**EU Peer Review Report of
the Belarus Stress Tests**

June 2018

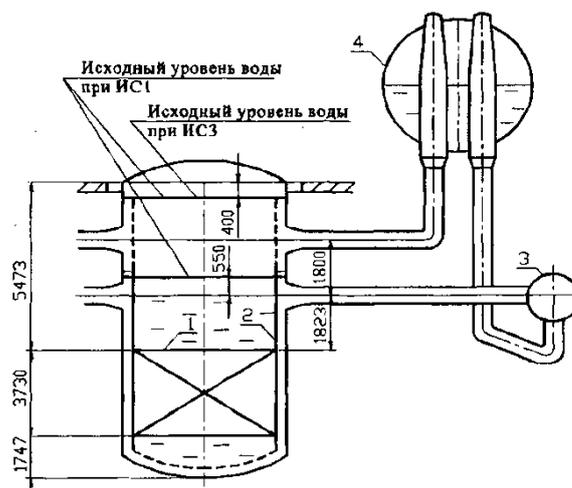
Mass yield of the primary circuit coolant through leakages after 72 hours is approximately 41 tons. Mass of steam discharged through the steam dump devices of the second circuit during the considered time interval is about 210 tons.

To avoid the previous described cliff edge effect a refill of the SG PHRS tanks is needed. For this purpose a water make-up system is installed.

Making-up of the SG PHRS tanks is provided by low-power high- pressure pump JNB50AP001 - designed as a single device- belonging to the make-up system for the emergency heat removal. The SG PHRS tanks are made up by low-power high-pressure pump JNB50AP001 made as a single unit and which is a part of the system for making up the emergency heat removal systems. This air cooled pump is located in the steam chamber (building UJE) and is connected to the tanks of system LCU (LCU 01, LCU 02, LCU 03 and LCU 04), each with a capacity of 700 m³. If necessary, pump JNB50AP001 can be fed from any of the LCU01-04 tanks by switching over the respective valves from the BDBA I&C

The pump JNB50AP001 is powered from the BDBA power supply "channel 7". For this purpose the mobile 500-kV diesel generator must be connected to the channel 7 switch gear to provide sufficient energy for the pump operation. As a second cliff edge effect, the loss of spent fuel cooling in the spent fuel pool has to be considered. A SBO leads to the failure of the spent fuel pool cooling system (FAK) and the alternative standby cooling channels. In this case at a first stage, cooling of spent nuclear fuel in the fuel pool is performed by heating up of the water inventory in the spent fuel pool and the following evaporation of the water into inner containment atmosphere.
